REQUEST FOR RECONSIDERATION  
SUBFY2024-0006 – Edgemere Subdivision  
City Council Decision Dated February 23, 2026

# EDGEMERE SUBDIVISION

# PRELIMINARY PLAT FOR EDGEMERE SUBDIVISION 219 E 44TH STREET GARDEN CITY ID, A PORTION OF LOT 23, BLOCK 3 FAIRVIEW ACRES SUB NO. 1 MARCH 2026

## OPEN SPACE (LANDSCAPING AREA) EXHIBIT

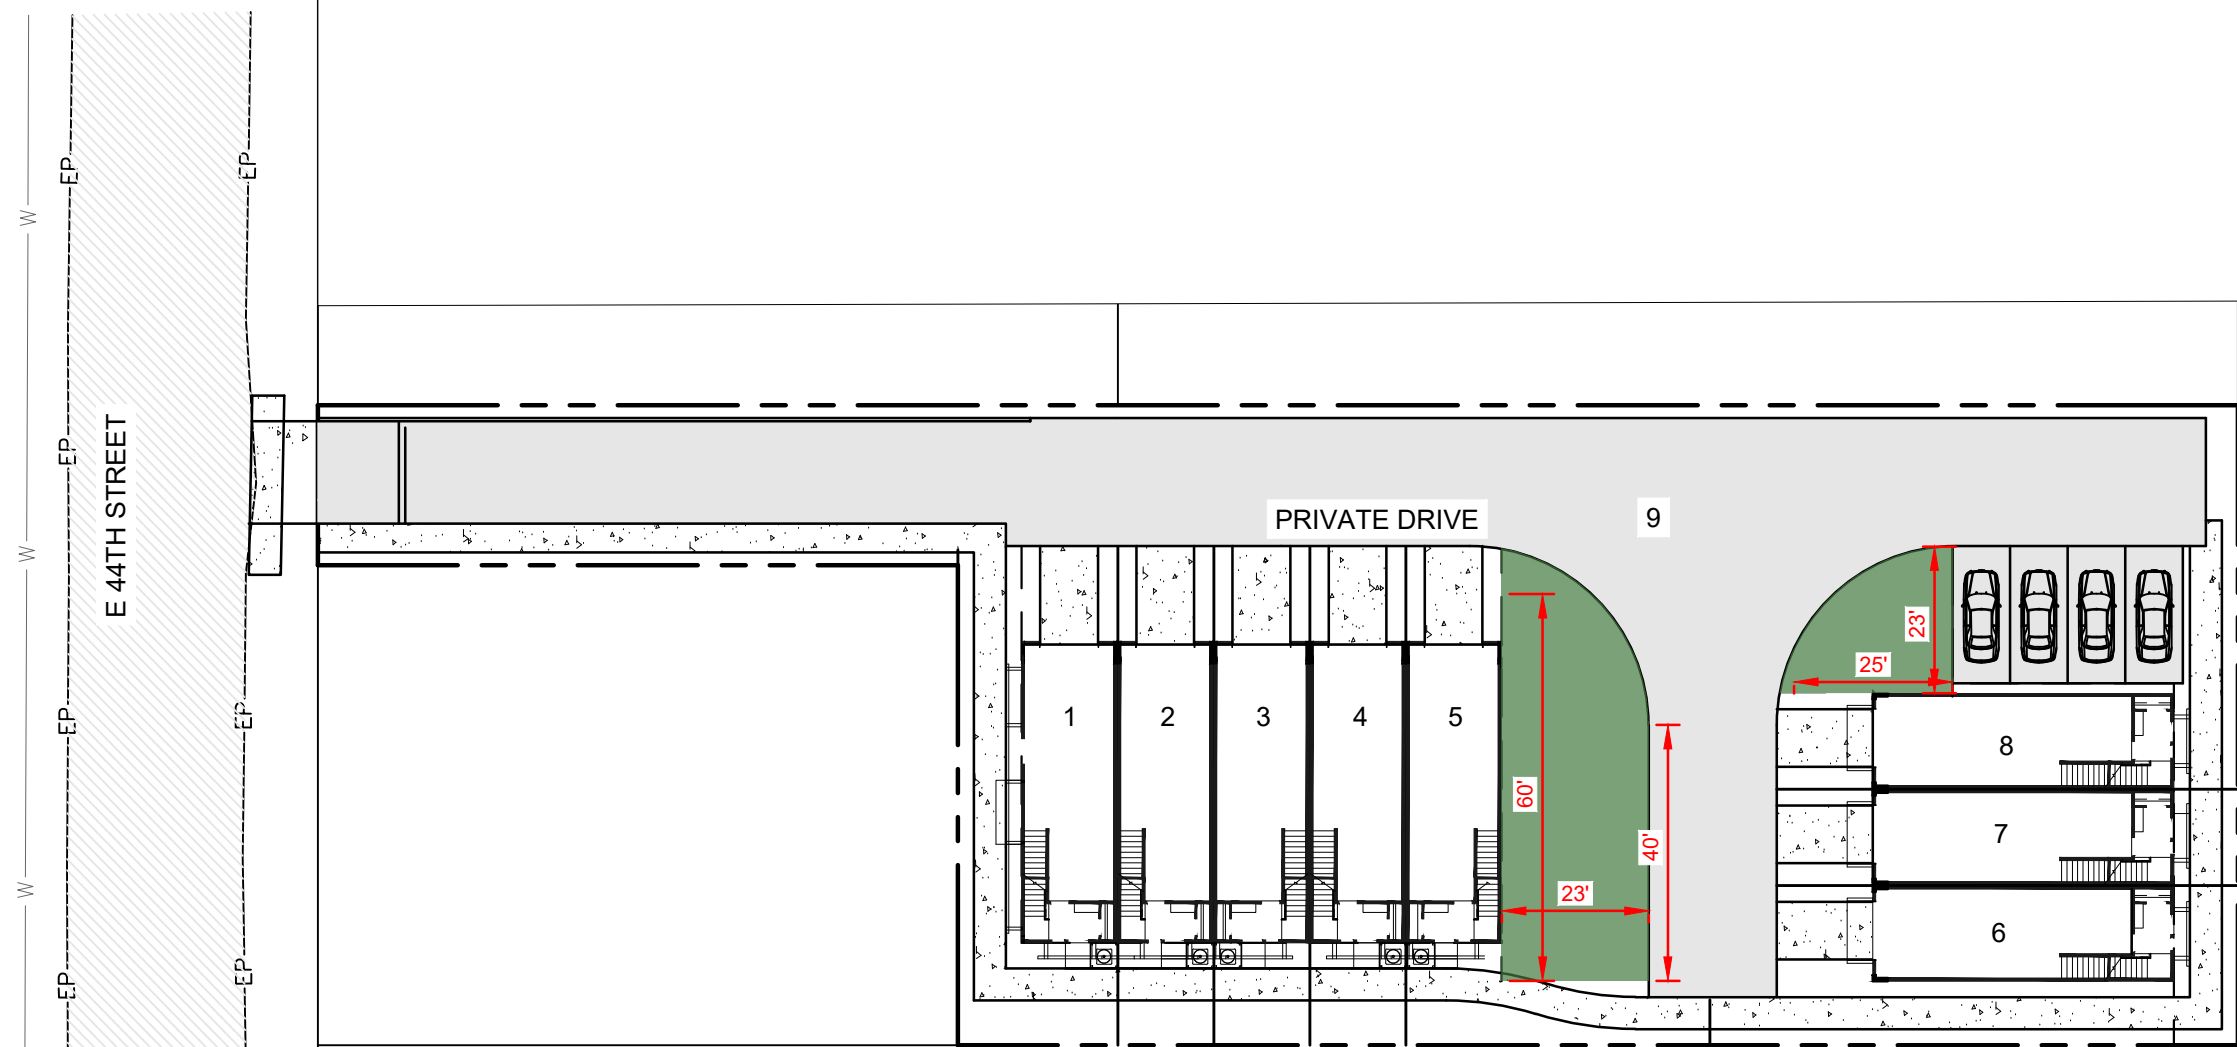
The Council's Findings identified concerns related to the configuration of open space and the amount of landscaping located outside required setbacks.

Landscaped areas located outside required setbacks have also been increased. These areas have been more clearly identified in updated exhibits to allow staff and Council to review them separately from setback areas.

1. THE AREA HIGHLIGHTED IN GREEN IS APPROXIMATELY 1,861 S.F.

## OPEN SPACE EXHIBIT

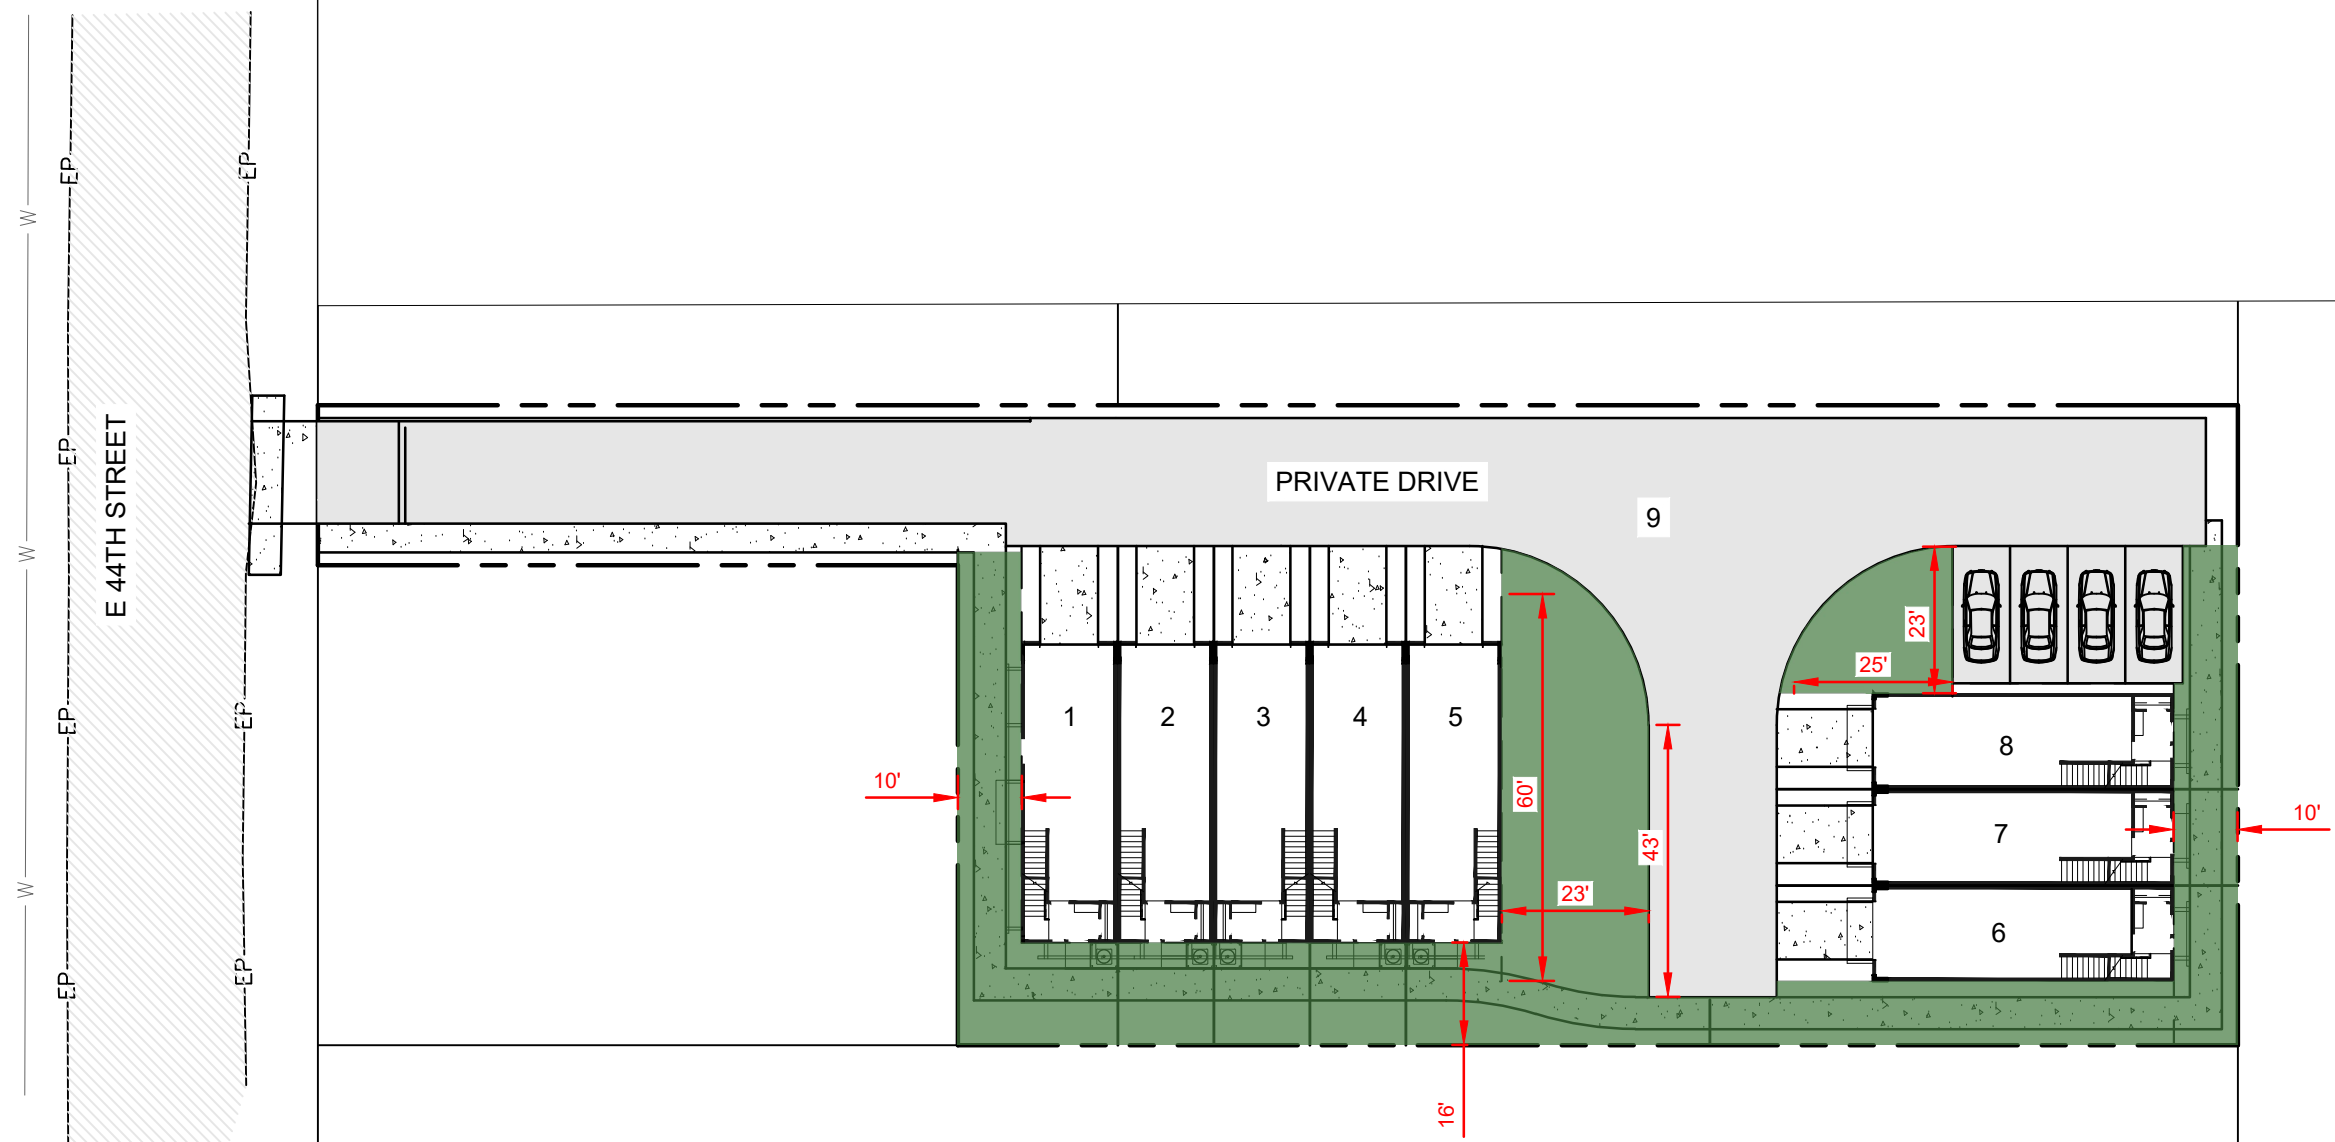
In response, the revised plan increases total open space. Portions of the pedestrian pathway area and the interior open space near the turnaround have been widened to create more usable areas.

1. THE AREA HIGHLIGHTED IN GREEN IS APPROXIMATELY 5,578 S.F.

**EDGEMERE SUBDIVISION  
 SUBDIVISION MAP**

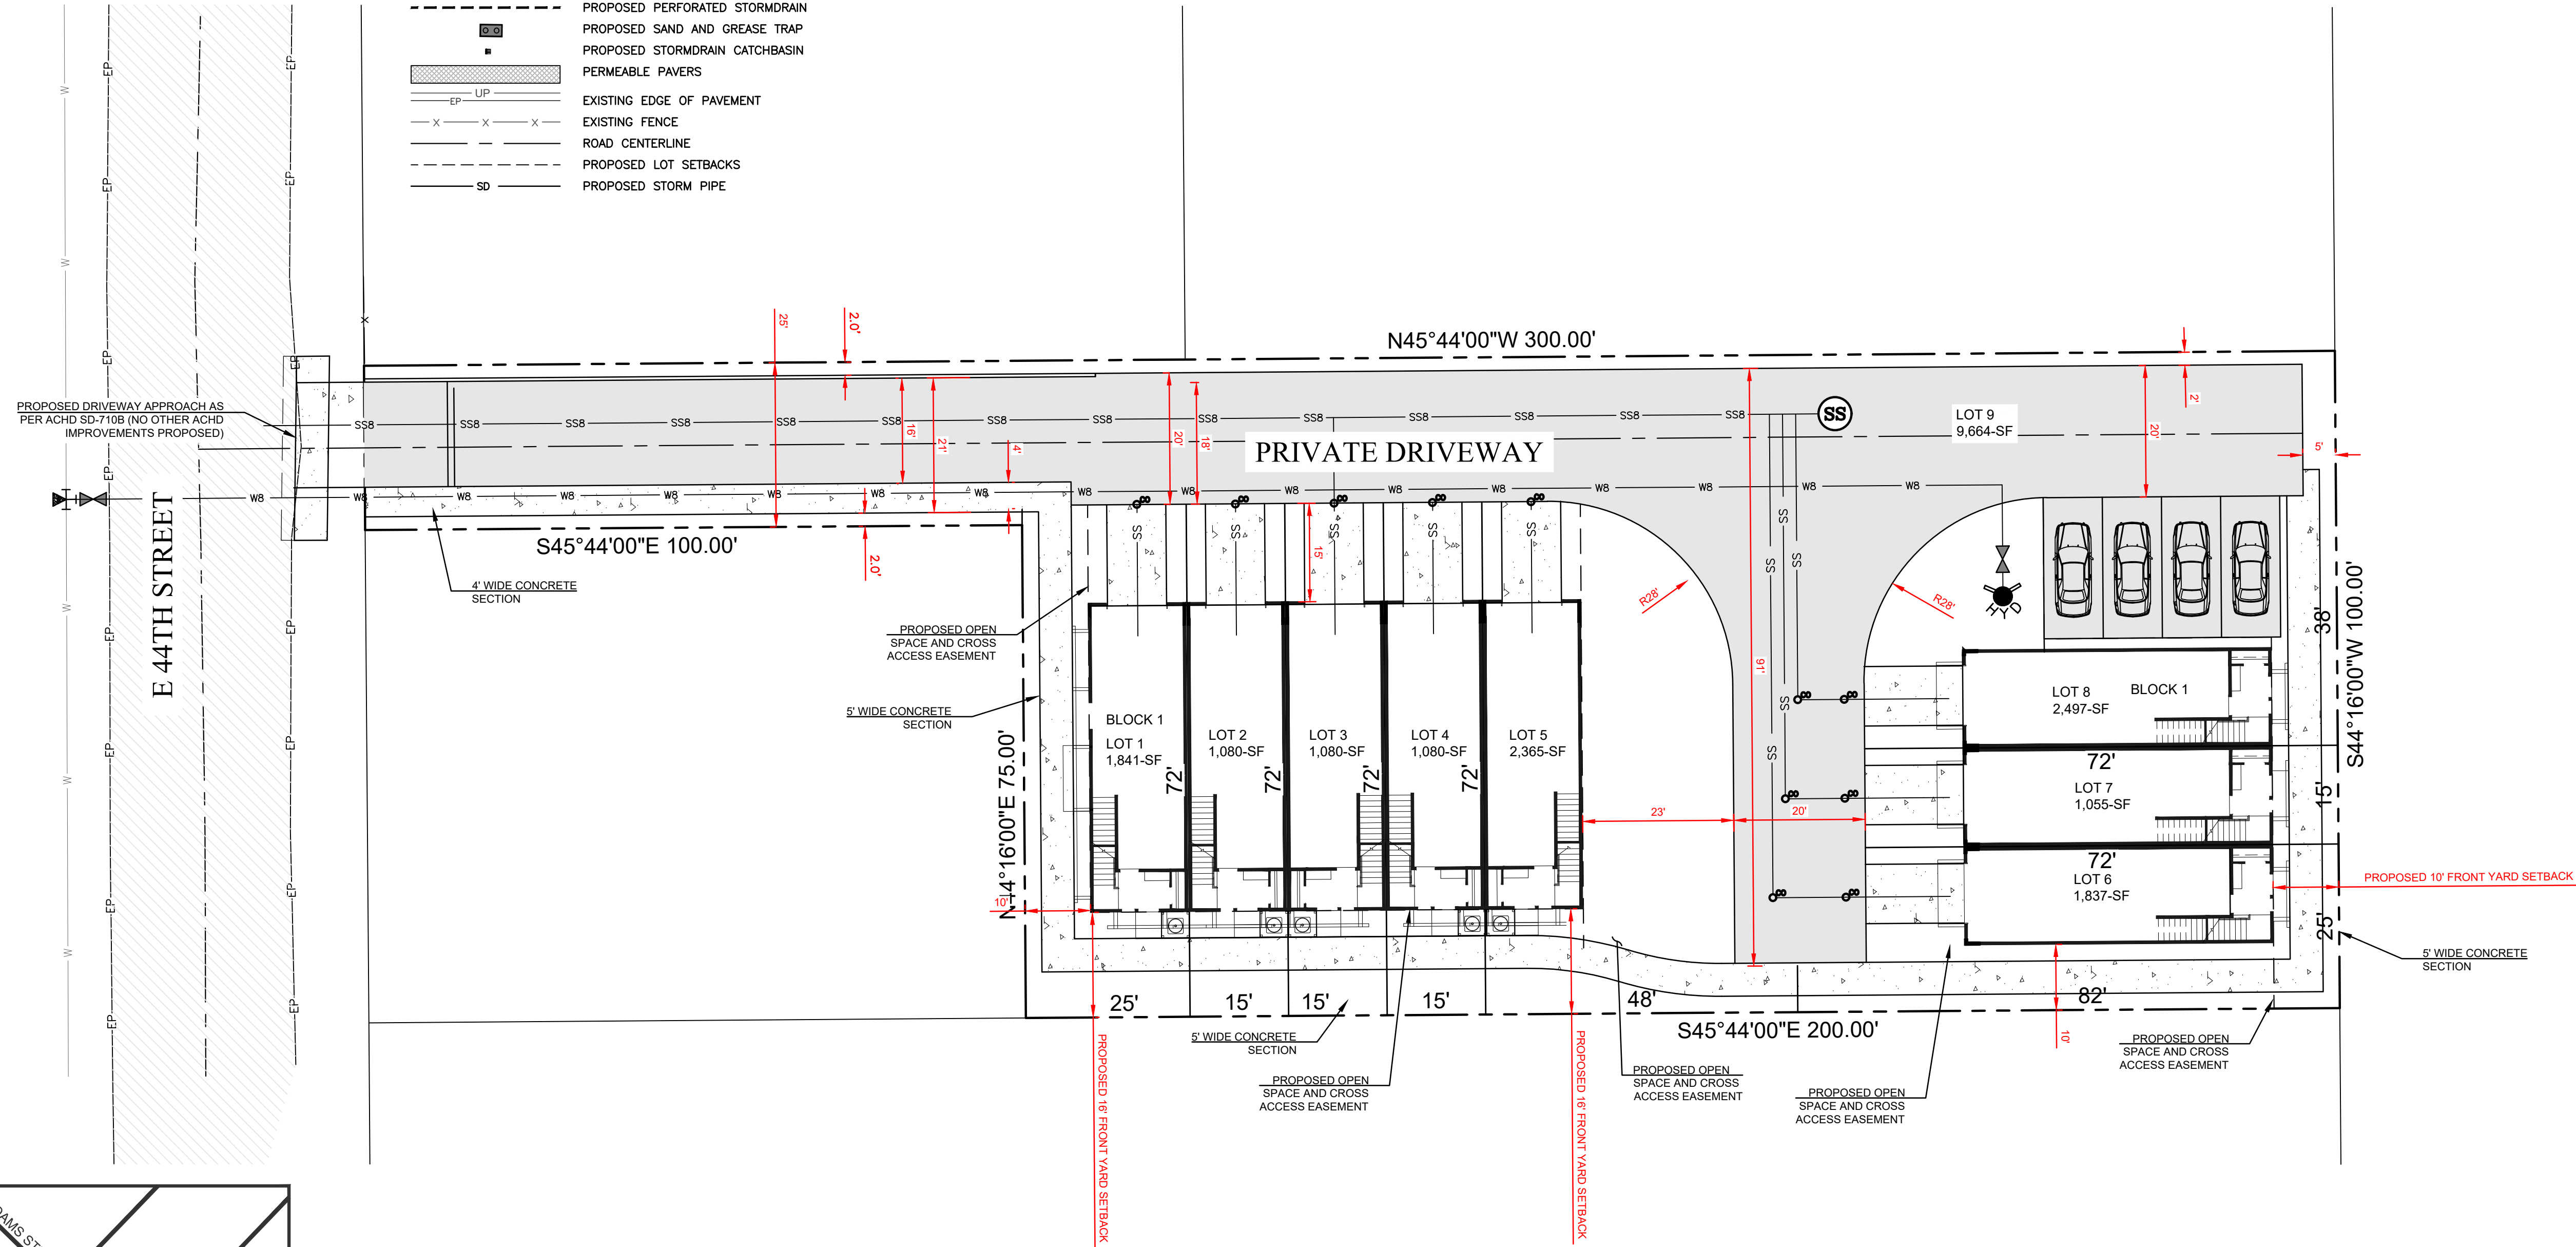
The revised plan increases garage depth to forty feet. Each garage now provides two tandem parking stalls, each measuring ten feet in width by twenty feet in depth. This adjustment removes the need for the prior dimensional deviation related to garage depth.

The revised plan continues to provide two enclosed parking spaces per dwelling unit. In addition, four full-size guest parking stalls have been incorporated into the site plan.

The Fire Department indicated that a reduced drive width could be acceptable provided that a fifteen-foot separation from the building to the edge of the travel way is maintained and that the buildings be equipped with fire sprinkler systems.

The revised plan maintains the required fifteen-foot building separation and incorporates the Fire Department's recommendations.
